**RE: Volcano Cliffs Subdivision Lot 3 Block 8 Unit 22
6420 Canavio Pl NW
Grading and Drainage Plan
Engineers Stamp Date 4/15/15 (D10D003E3)**

DRAINAGE AND TRANSPORTATION INFORMATION SHEET

GRADING AND DRAINAGE PLAN
LOT 3 , BLOCK 8 , UNIT 22 , VCS
ADDRESS: 6420 Canavio PL NW

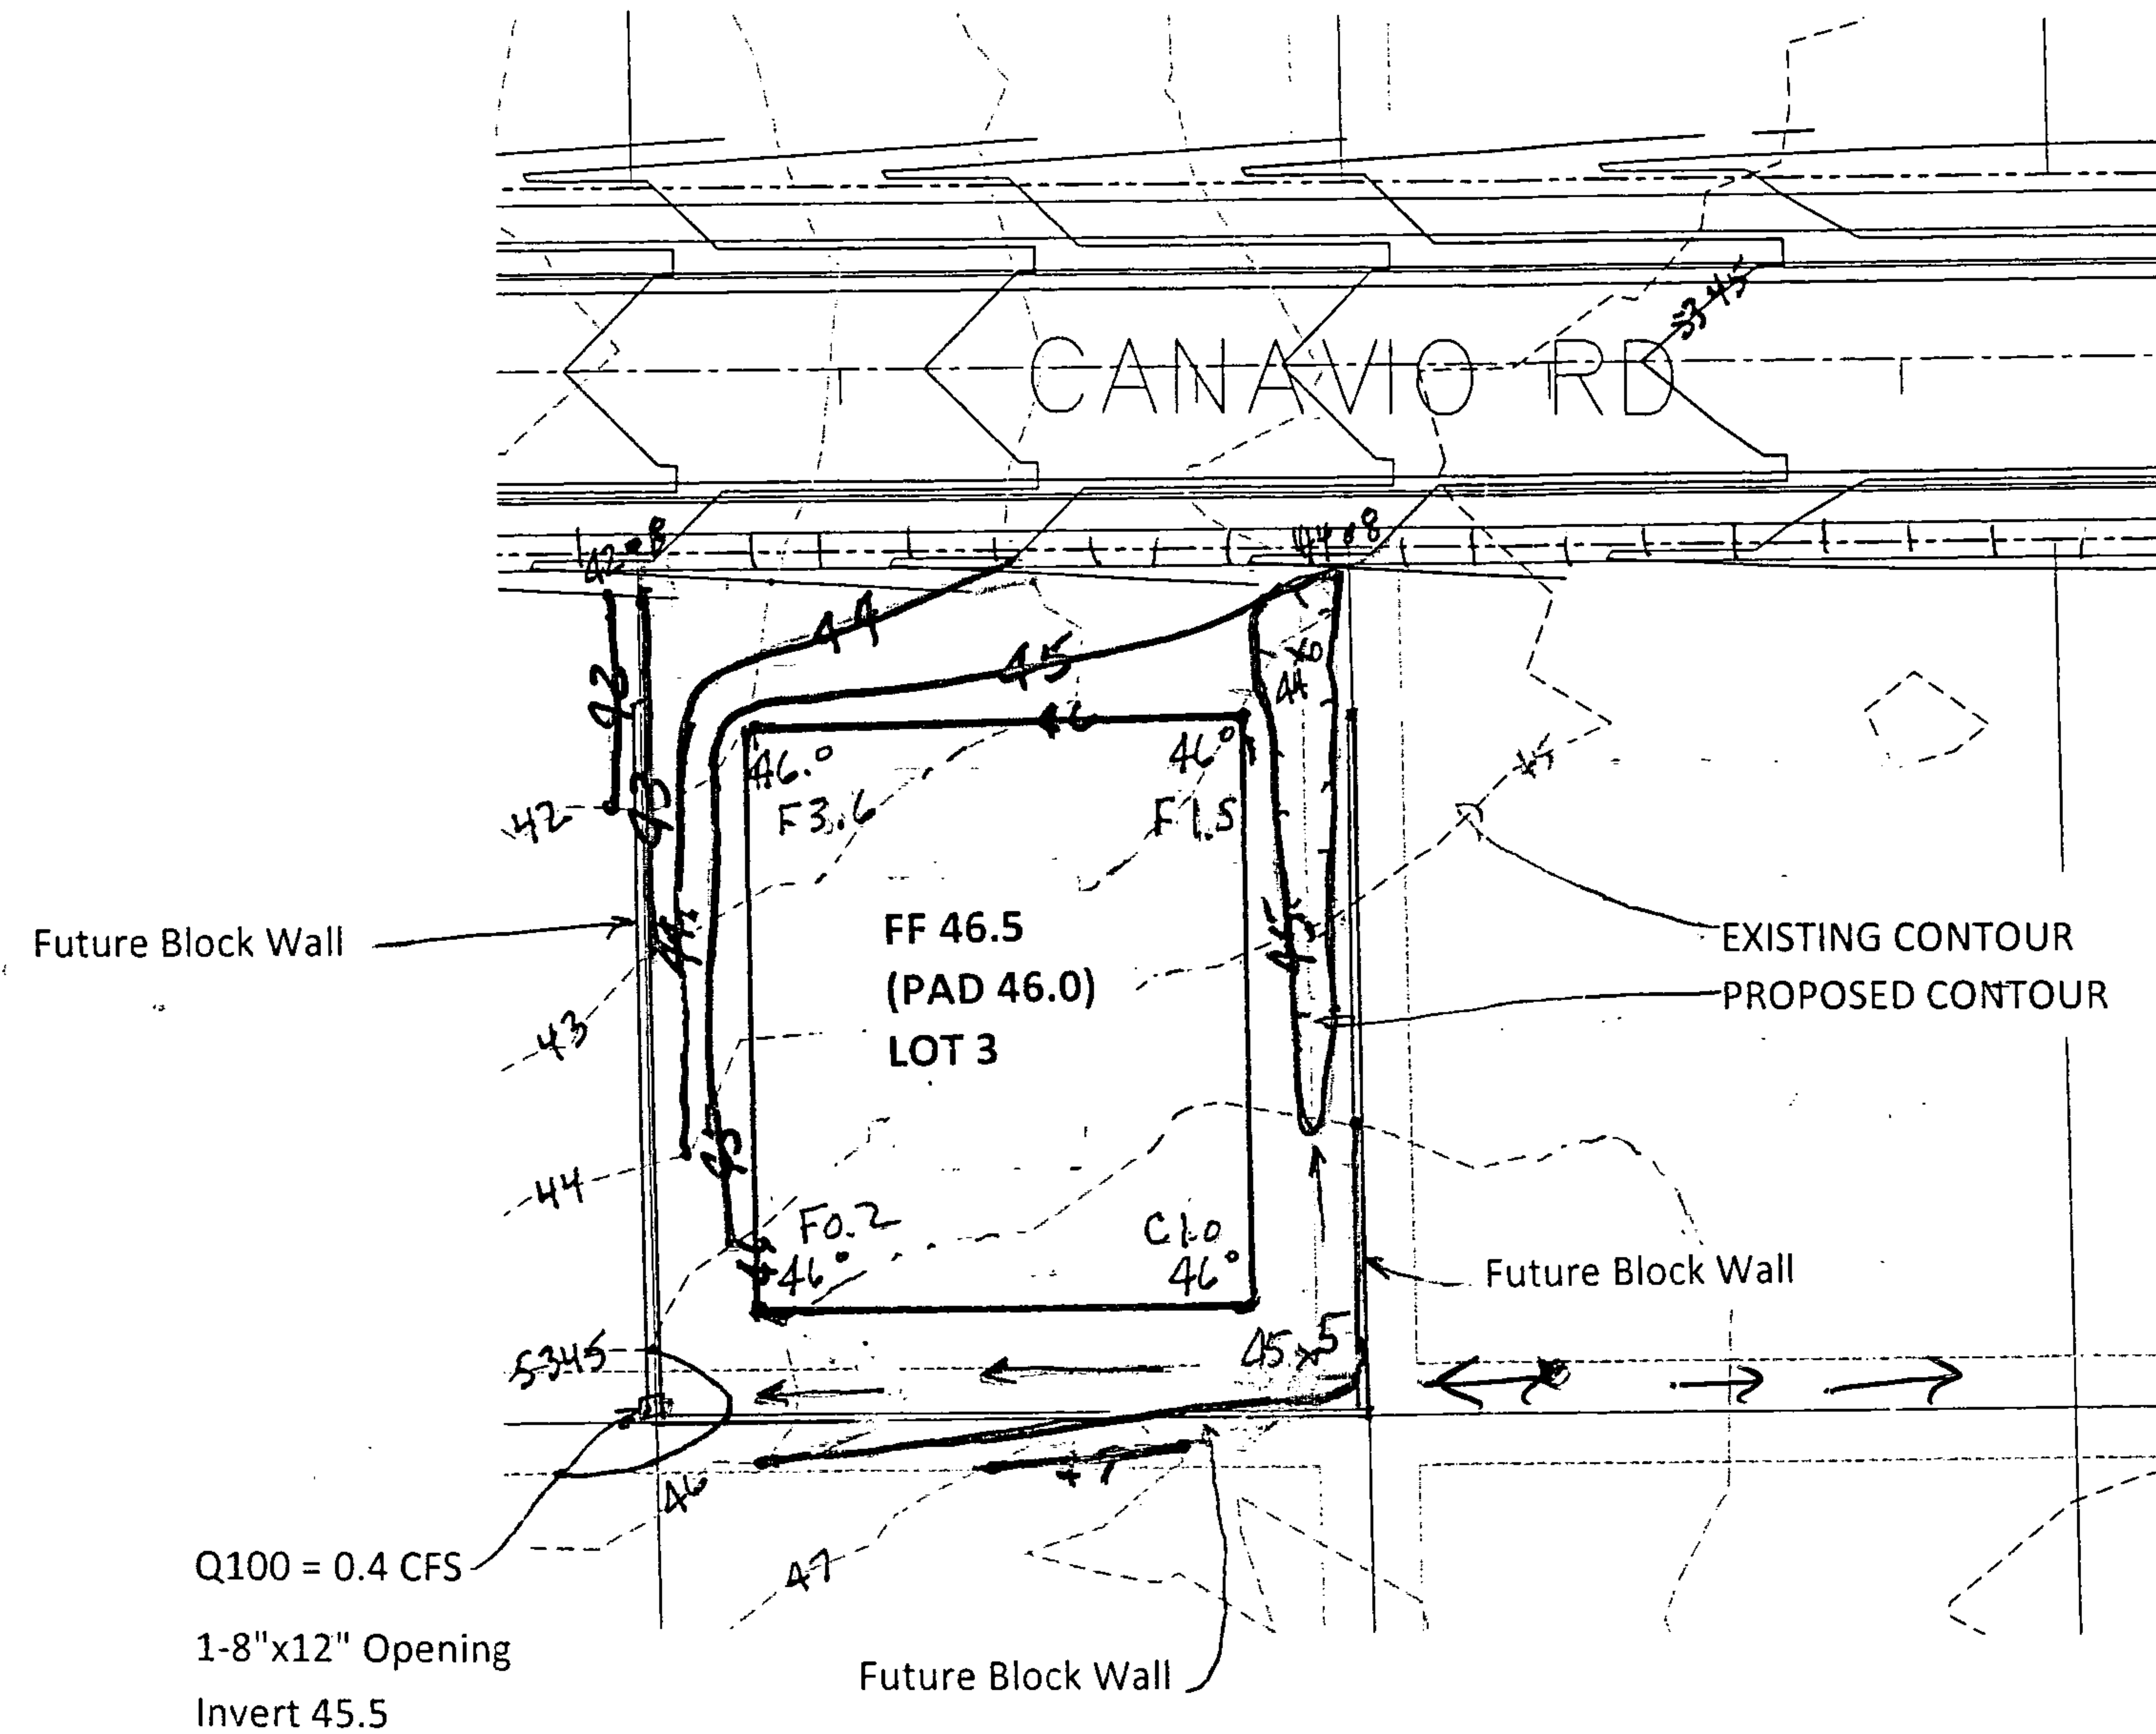
Based upon the information provided in your submittal received 4/15/15, this plan is approved for Grading Permit and Building Permit.

Please attach a copy of this approved plan to the construction sets in the permitting process prior to sign-off by Hydrology.

Prior to Certificate of Occupancy release, Engineer Certification per the DPM checklist will be required.
